World Forum for Harmonization of Vehicle Regulations**Working Party on Pollution and Energy****Sixtieth session**

Item 3 of the provisional agenda

Particle Measurement Programme**Proposal for a Corrigendum to Supplement 7 to the 05 series
of amendments to Regulation No. 83
(Emissions of M₁ and N₁ vehicles)****Submitted by the expert from the United Kingdom ***

“Figure 13
Particulate sampling probe configuration”

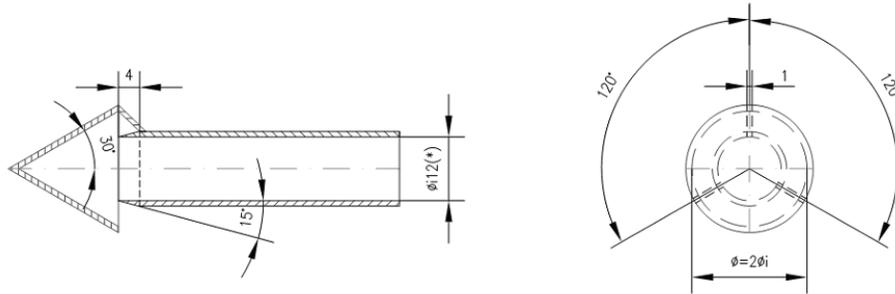
Annex 4a, Appendix 4, Figure 13, replace with:

(*) Minimum internal diameter
 Wall thickness ~ 1 mm - Material: stainless steel
